883 Congress St.

Garage, Office, overpass

Re: MAINE MEDICAL CENTER REVISED PLANS

**RE: Maine Medical Center Office Building**

Level 2

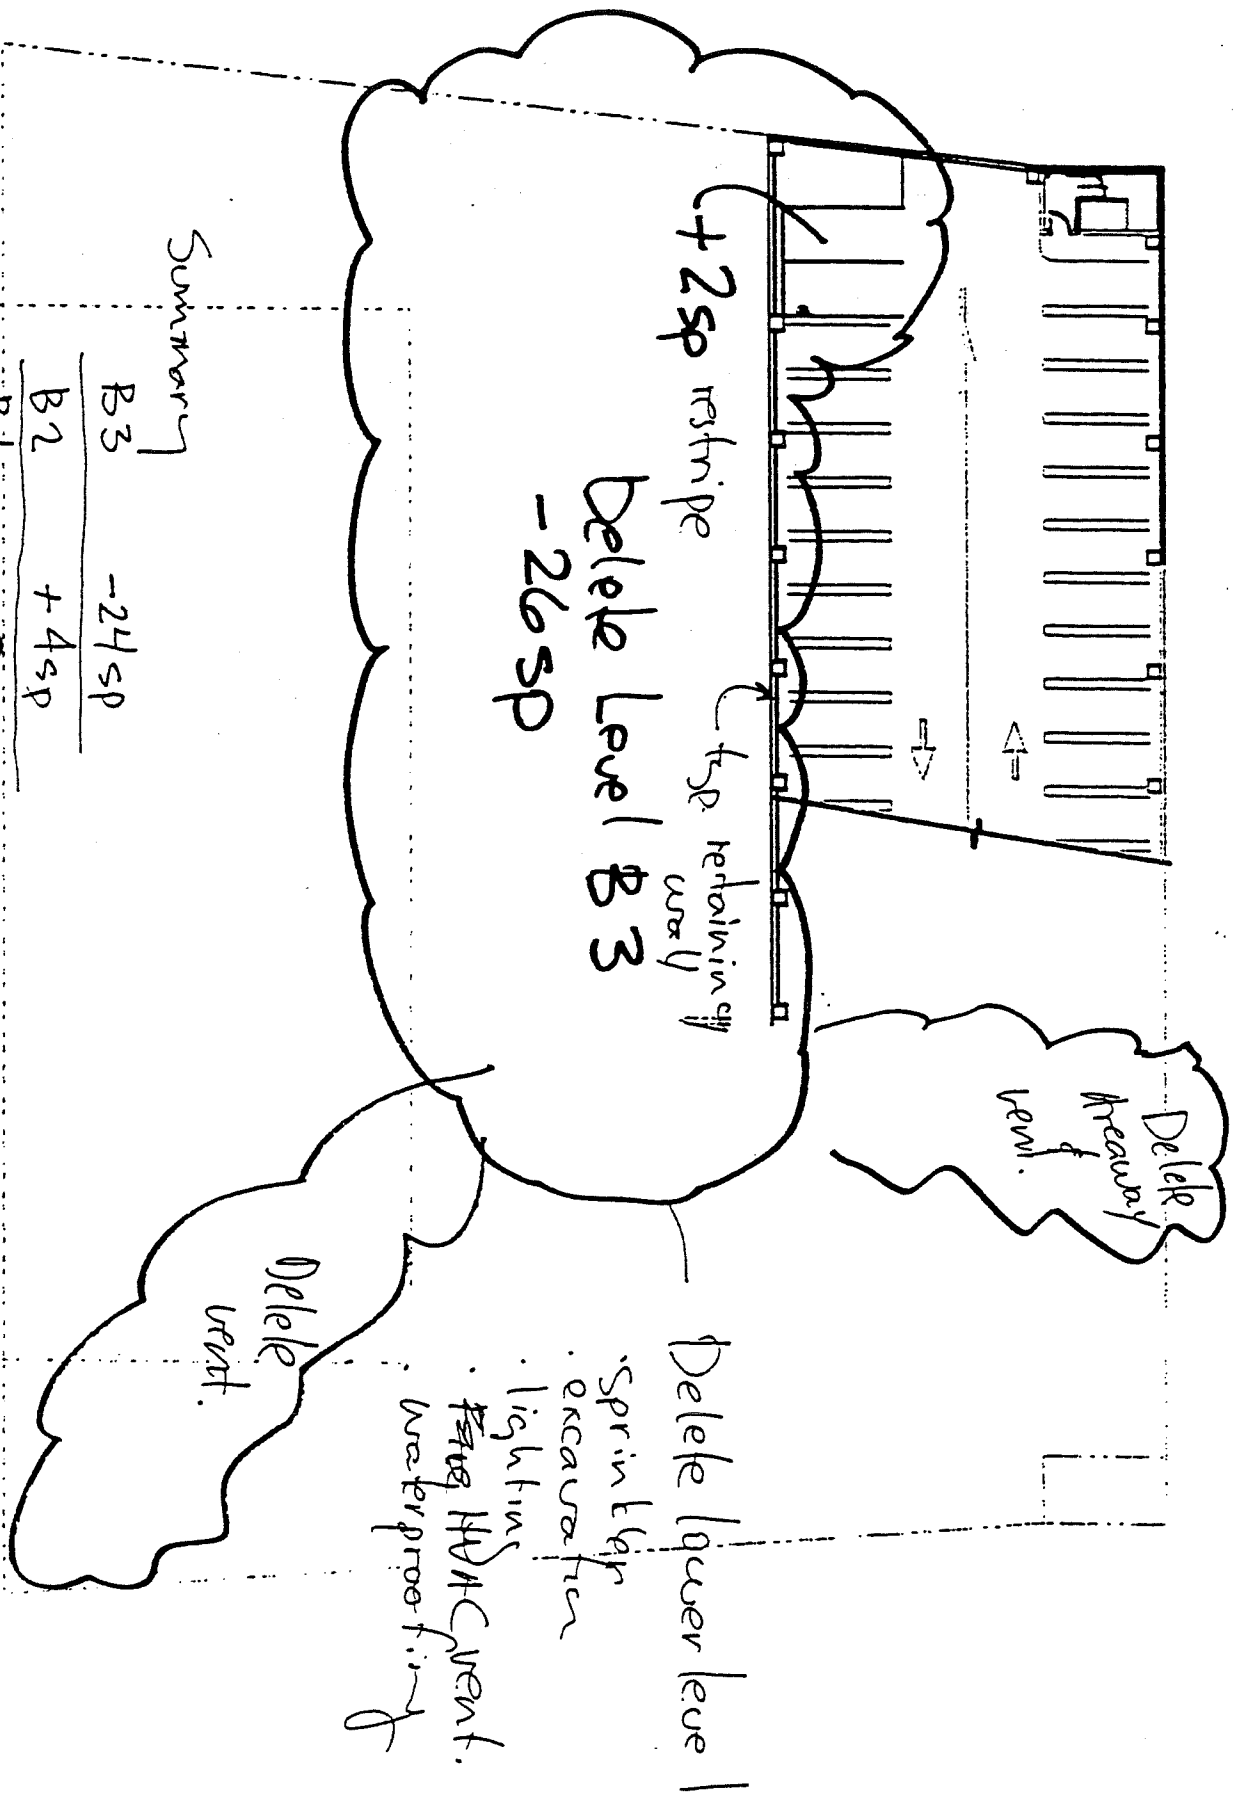
Staff has reviewed the submitted drawings including the overlay plan. We do not have any objections to the revised plan; however, before we sign-off on the changes, please submit the following information:

- a. A summary of the number of parking spaces on each level (original plan vs. revised plan) with a grand total showing the same number of spaces.
- b. A letter from Maine Medical Center that the revised plan will not affect their pledge to preserve Sea Dog parking and resident snowday parking.
- c. A definitive statement that the exterior appearance of the parking garage remains the same.

Shift stair  
Reshape to add 2 spaces

Reshape to add 1 sp.

+1 sp  
restripe

Delete Ballards  
and drive  
lane — restrip

17 sp  
new divider.

+2sp restripe

C4

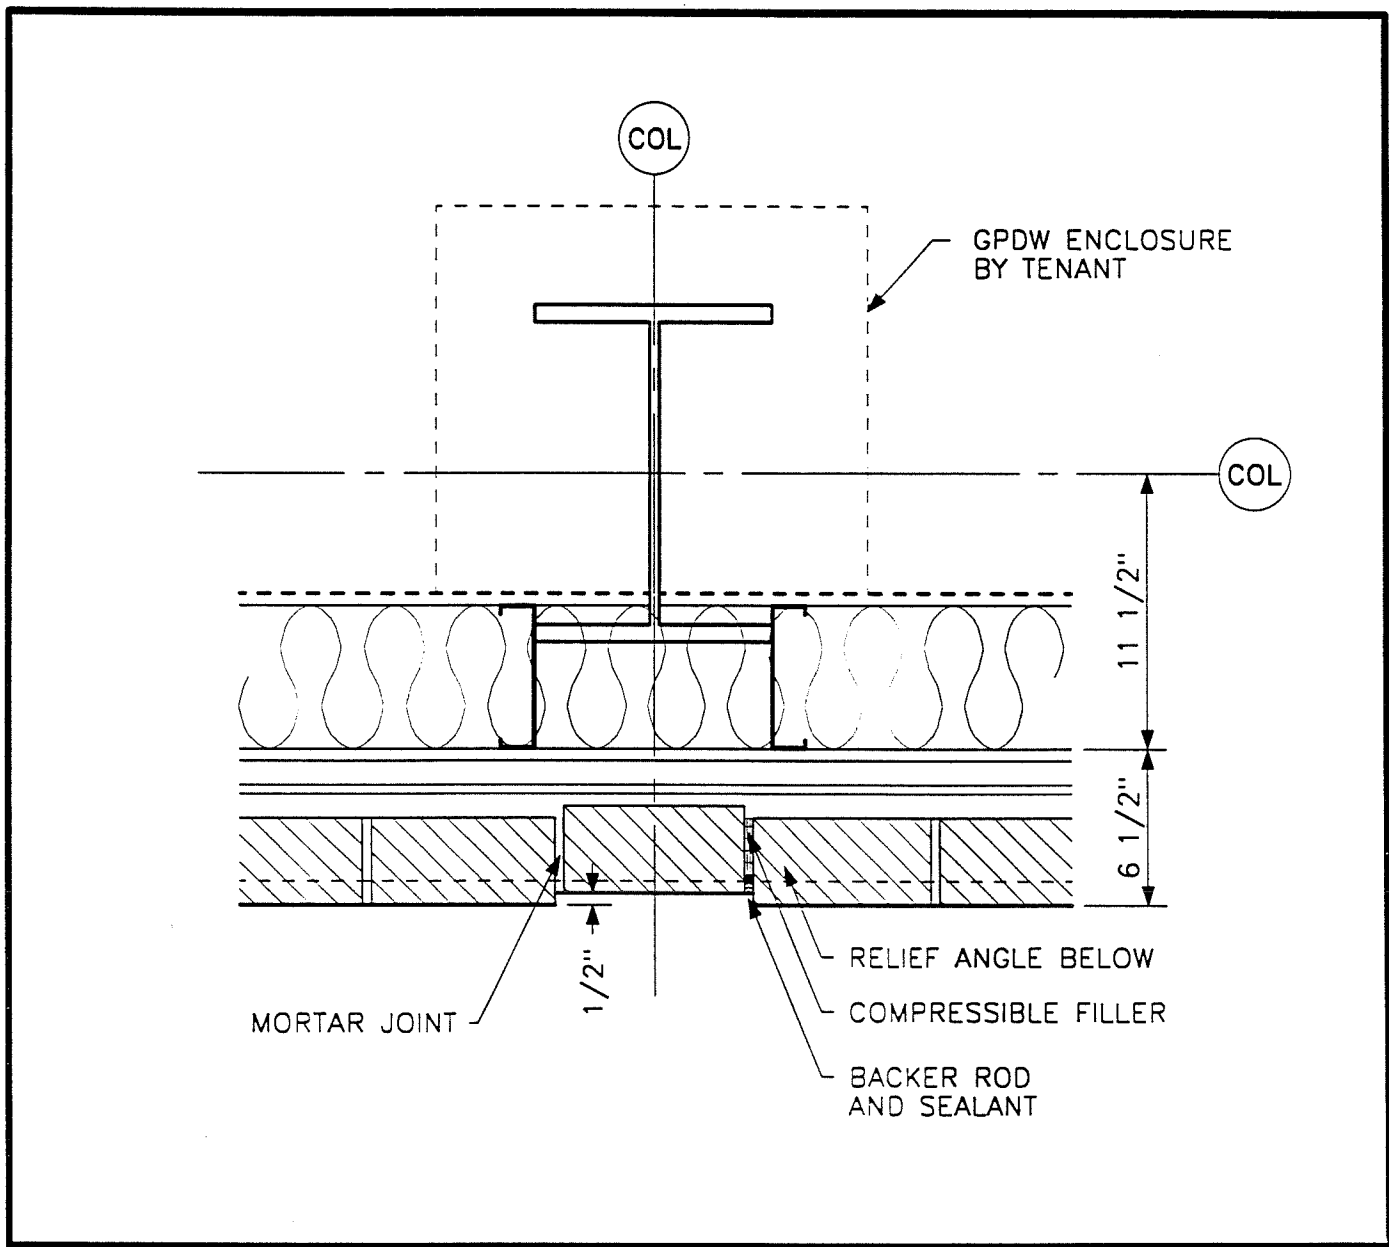
I know the larger brick is economical, but the smaller brick is in keeping with the architectural character of Portland. We do not feel comfortable approving this change. Also, we have concerns about the change in the cornice line detail. The original detail worked much better than your latest proposal.

See attached detail drawing C4 for information on recessed brick.
